Generic Design Assessment – New Civil Reactor Build

Step 4 Electrical Systems Assessment of the Westinghouse AP1000[®] Reactor

Assessment Report: ONR-GDA-AR-11-007

10 November 2011

Figure 1: Busbar Voltage and UAT Current following AVR increase (Full Load)

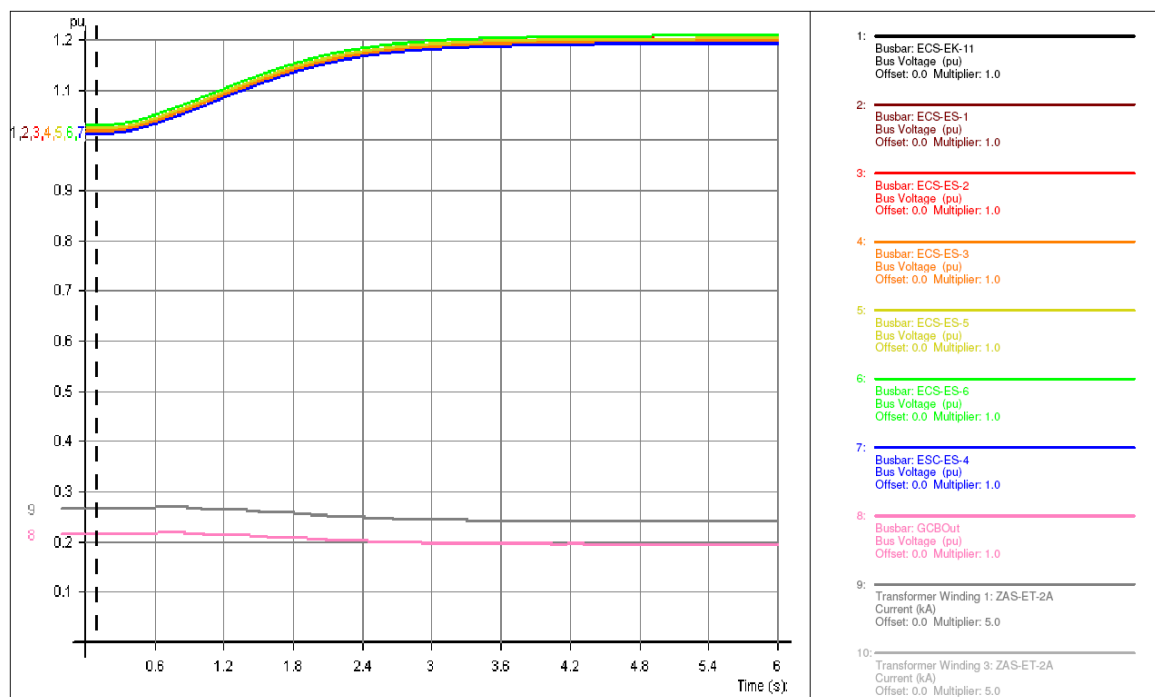
118 At a study time of $t = 0.1\text{s}$ the Main Alternator AVR reference point set was altered from 1 to 1.3pu ¹ to simulate a possible failure of the AVR in regulation performance. The simulation was of the effect of the failure rather than attempting to recreate precisely an actual AVR mode of failure.

119 Similar voltage increases were obtained for both scenarios with a 1.3pu AVR reference change resulting in voltages of 1.15pu to 1.2pu on the system busbars. The sustained overvoltage condition was reached in 1 second with the alternator on low load and 5 seconds with the alternator on full load.

- 121 The potential for an AVR failure to result in significant overvoltages on the Plant Electrical System has been demonstrated by the studies which have been undertaken.

- 122 I consider that protective measures proposed by Westinghouse to protect against the risk of an AVR fault are comprehensive and effective.
- 123 Assessment Finding **AF-AP1000-EE-008** requires the future licensee to carry out transient studies for each power plant to address the consequences of AVR failure for the actual equipment to be installed on an AP1000 in the UK. These studies should address the following:

Figure 2: Fast Bus Transfer with a Dead Time of 48ms

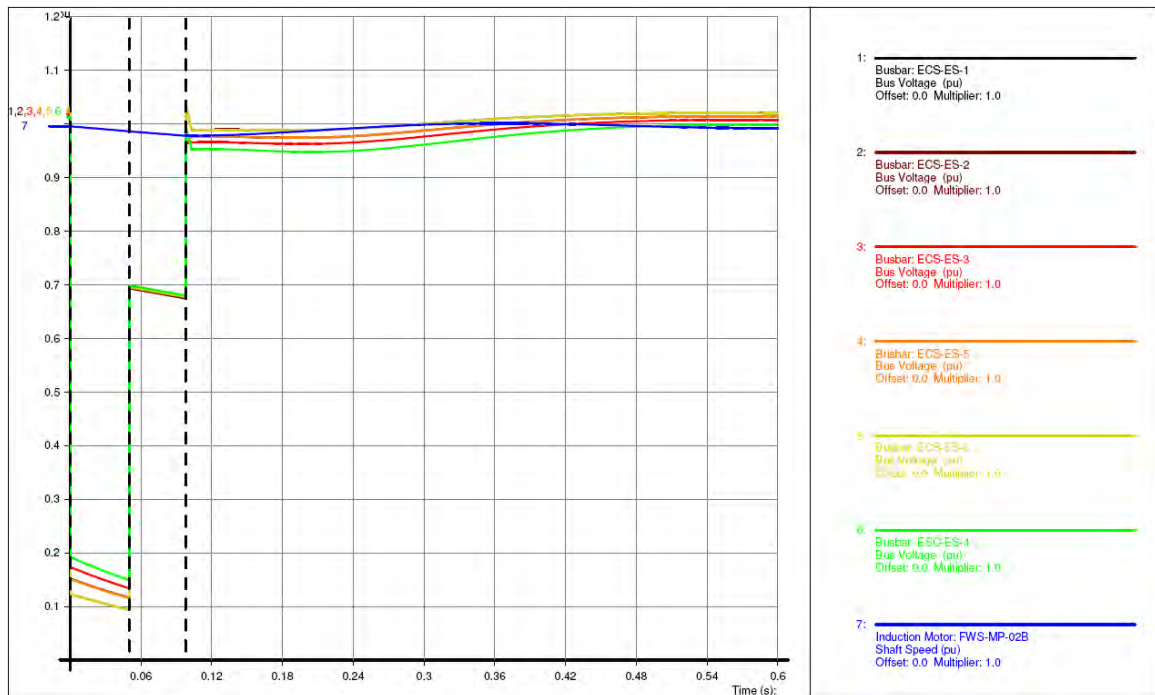
- Fast bus transfer with an assumed dead bus time of 48ms shown in Figure 2.
- Residual bus transfer with an assumed dead bus time of 3.076s shown in Figure 3.
- Fast bus transfer with delay in opening of the UAT circuit breaker M1 which results in an overlap time with both circuit breakers closed of 52ms shown in Figure 4.

136 The studies show that fast bus transfer results in voltages of the order of 90% initially with the voltage recovering within 1s which is acceptable.

Figure 4: Fast Bus Transfer with Overlap Time of 52ms

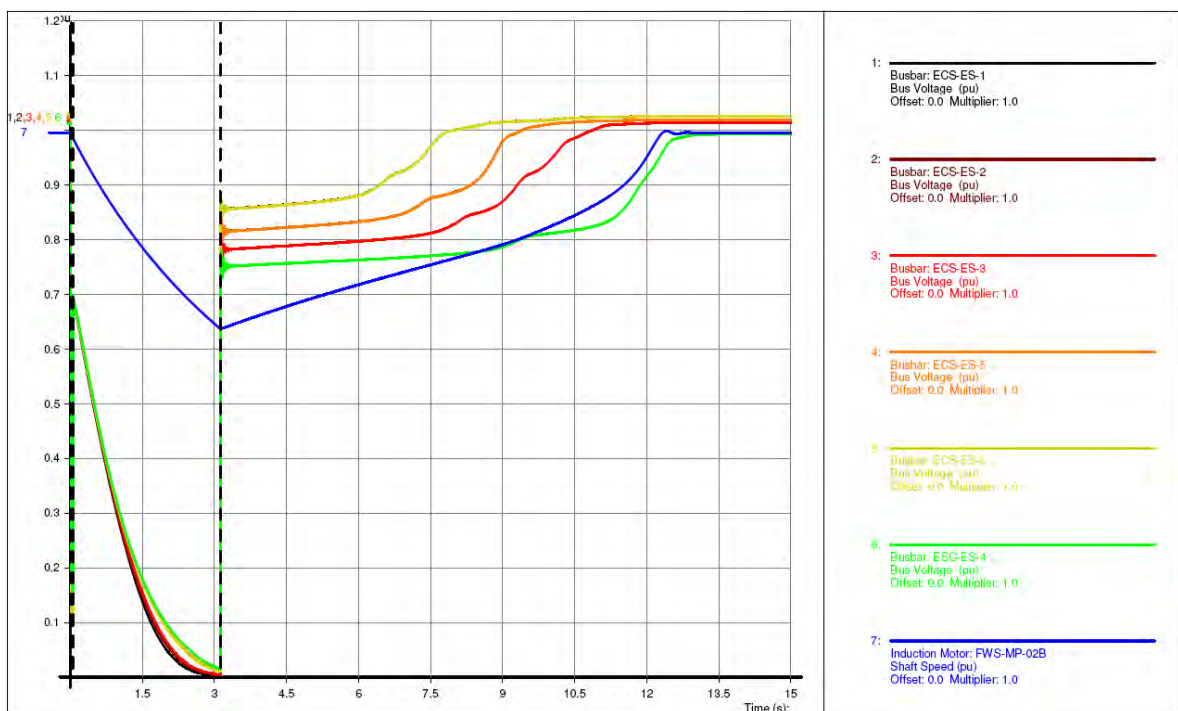
138 An overlap due to delayed opening of M1 circuit breaker could result in overcurrent stresses on both UAT and RAT. The Westinghouse response to TQ-AP1000-1105 (Ref. 8) states that electrical protection is provided during automatic transfer as the initiating event will be a short-circuit and overcurrent protection will operate to trip circuit breaker M2 and thus de-energise the bus.

139 A failure to trip M1 during manual transfer would result in the supplies from UAT and RAT being paralleled. Protection would be required to prevent this situation occurring.

- 140 I consider that the fast bus transfer operation does not have any adverse effects on the integrity of the Electrical Distribution System and its function to ensure nuclear safety provided that protection settings and lock-out times to initiate residual bus transfer are correct. These aspects are critical to the successful implementation of the scheme so will require detailed study by the future licensee.

Figure 5: Scenario 1: Islanding Following a 0.2s three phase Fault at Grid Connection

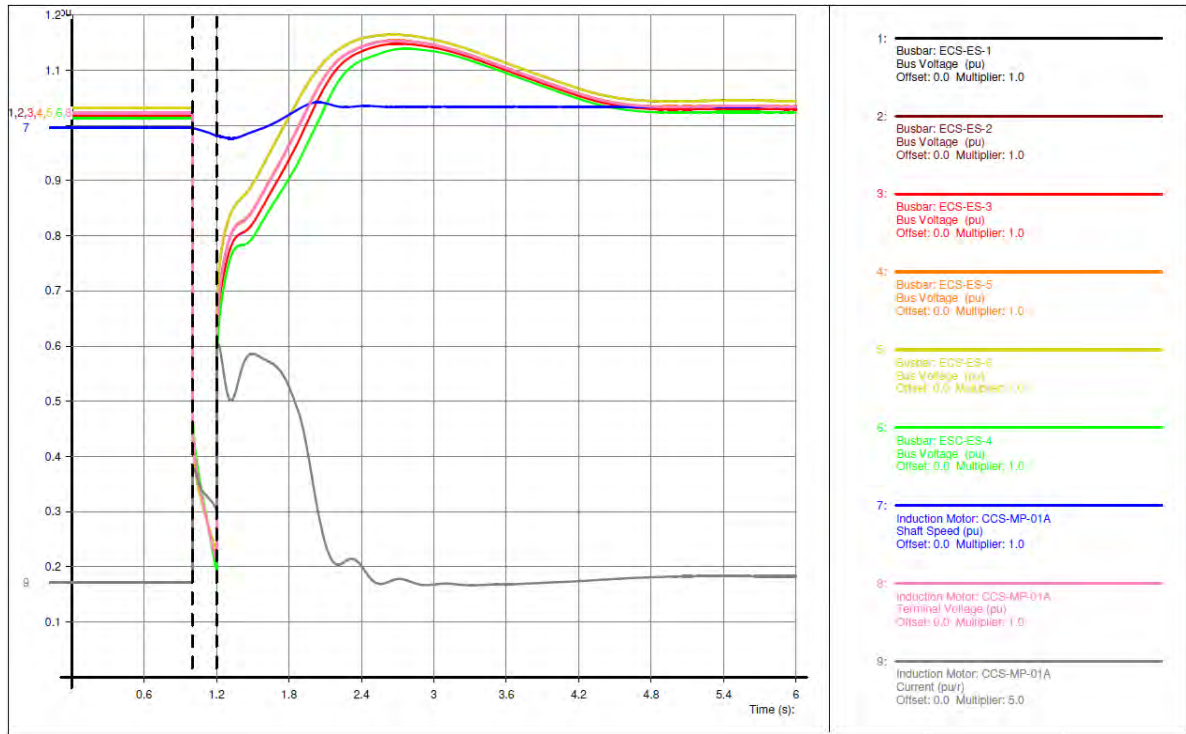
- 168 The results for Scenario 1 are shown in Figure 5. At the inception of the fault the Main Generator contributes fault current via the MSUT and a proportion of the system voltage is maintained. On fault clearance the voltage recovers at the same time as the generator AVR is increasing the excitation to maintain system voltage which results in an overvoltage on the first cycle of the recovery voltage. The transient voltage at switchboard ECS-ES-6 reaches a maximum value of 1.164pu.
- 169 Scenario 2 with a 0.5s fault produces similar results to Scenario 1 with a marginal increase in the maximum transient voltage at switchboard ECS-ES-6 to 1.178pu.
- 170 Scenario 3 considers the 0.2s fault as for Scenario 1 but with the conventional island motor load tripped during the fault. This is done to consider the impact of the post-fault

current demand on the system voltage and results in a maximum transient voltage at switchboard ECS-ES-6 of 1.18pu.

- 174 I consider that the future licensee should conduct studies to consider the effects of islanding of the Electrical System based on actual site arrangements using detail design data specific to the AP1000 in the UK. This should take account of scenarios with and without prior faults and should consider the range of power factors prior to the islanding of the plant. This requirement is the subject of Assessment Finding **AF-AP1000-EE-013**.

Figure 6: Scenario 4: 100% Load Rejection Without a Prior Grid Fault Condition

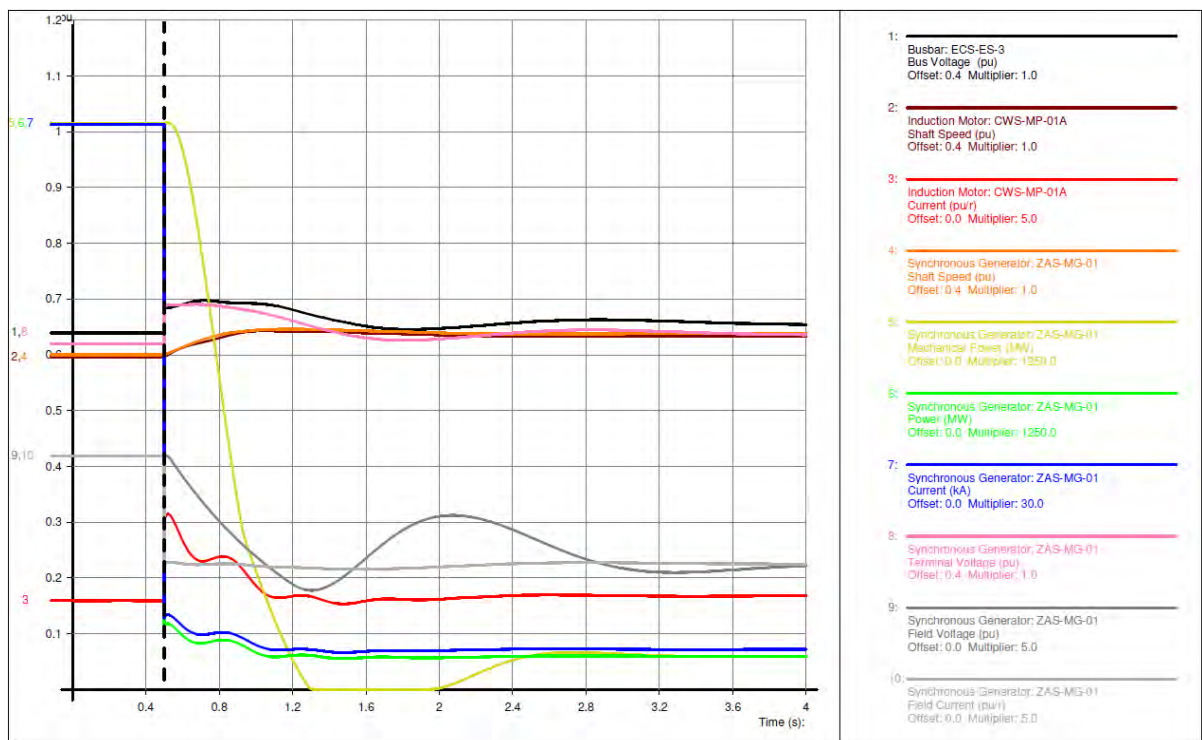
-
- 171 Scenario 4 considers a loss of grid connection resulting in islanding of the Main Generator with no prior grid fault condition. The results of this study are shown in Figure 6. This considers initial conditions of generator power output of 1266 MW which reduces to 74 MW on grid disconnection. The case considered resulted in a maximum transient voltage 1.09pu. Studies showed that this value is influenced by the reactive output of the generator prior to load rejection.
- 172 Studies have been carried out by Westinghouse investigating the effects of 100% load rejection of the Main Generator to an islanding condition. The results of these studies are recorded in Westinghouse document UKP-GW-GL-064 (Ref. 24). The results of the Westinghouse studies show a close correlation with the results from Scenario 4 of the studies conducted by the TSC.

- The reactive power output from the generator immediately prior to the islanding affects the value of the system overvoltage on recovery.
 - Westinghouse states that there is a contractual overvoltage limit of 118% following load rejection. The studies show that this value is not exceeded.

- I consider that the study results show that the islanding of the Plant Electrical System can be accepted by the system with overvoltages restricted to acceptable levels.

Figure 7: Scenario 1 - Post-Fault Recovery on Grid Fed from UAT with 200ms Fault

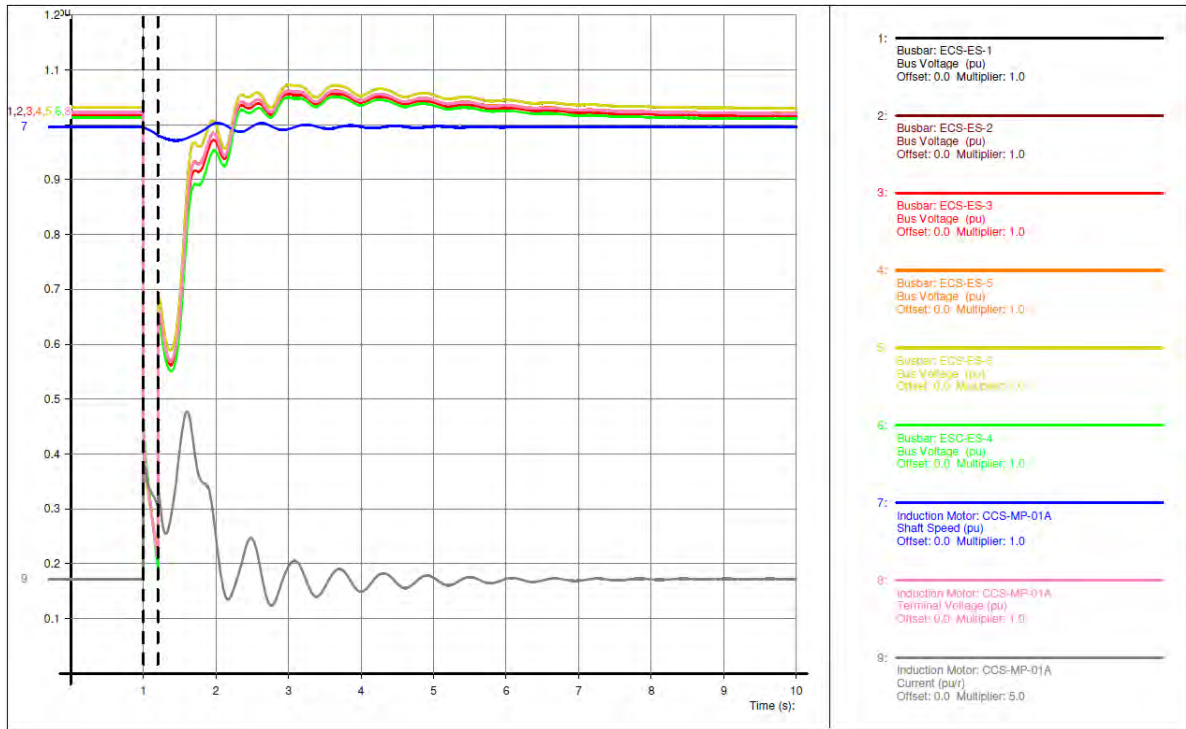
180 The results of Scenario 1 are shown in Figure 7. At the inception of the fault the generator contributes fault current via MSUT and a proportion of system voltage is maintained falling to approximately 20% by the end of the fault period. After the fault is cleared the voltage recovers whilst the AVR is increasing the excitation to maintain the terminal voltage which results in a transient overvoltage. The transient overvoltage at switchboard ECS-ES-6 reaches a maximum of 1.07pu 1.8s after fault clearance. The post-fault current in UAT is greater than the pre-fault current due to the demand from reaccelerating system motors which has the effect of limiting the peak transient overvoltage on the station busbars.

184 The future licensee shall conduct post-fault recovery studies for the system following grid faults based on actual site conditions. This is identified in Assessment Finding **AF-AP1000-EE-014**.

Figure 8: Scenario 2 - Post-Fault Recovery on Grid Fed from RAT with 200ms Fault

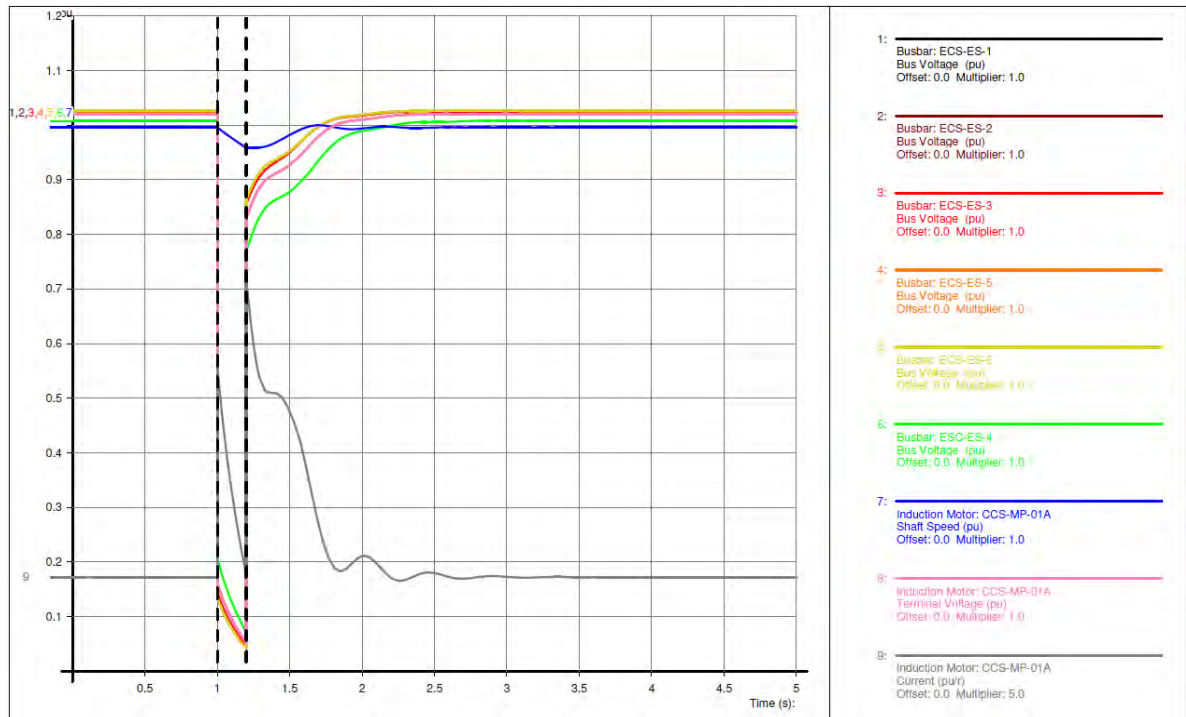
181 For Scenario 2, the results are shown in Figure 8. The supply is derived from a separate grid source which is not influenced by the Main Generator and thus the system response is different. The internal voltage drops to 5% as the mechanical energy from the rotation of the internal motors is the only form of voltage support. On fault clearance there is no overvoltage tendency as the generator is not providing voltage support via the AVR and the switchboard voltages recover at a rate determined by the reacceleration of station motors.

Figure 9: Scenario 3 - Post-fault Recovery on ECS-ES-3 With 100ms Fault Fed from UAT

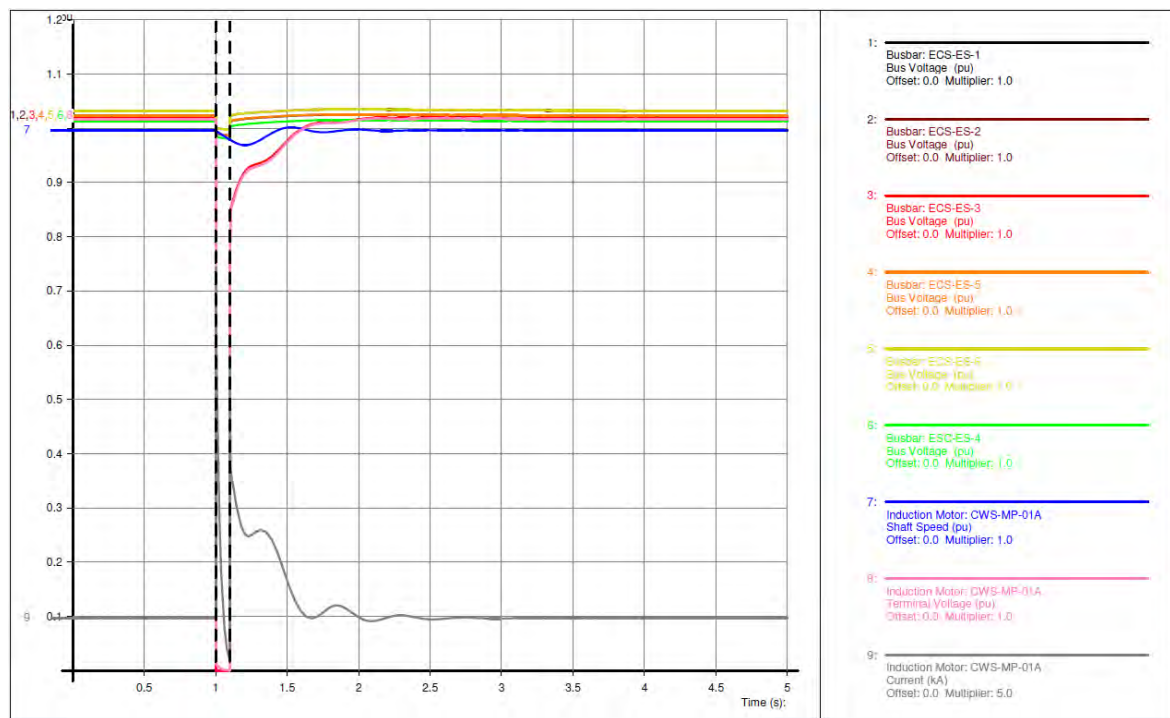
182 For Scenario 3, the results are shown in Figure 9. These results are typical for each of Scenarios 3 to 6. A fault on an internal switchboard leads to a deeper internal voltage depression. The voltage then returns to nominal more quickly following fault clearance due to the grid transformers preventing the source voltage being affected by the fault.

183 There is a good level of agreement between the studies performed by Westinghouse and by my TSC. No post-fault instability was found in any of the configurations or fault durations studied. I consider that this generic assessment shows a good resilience of the system to faults with good stability margins.
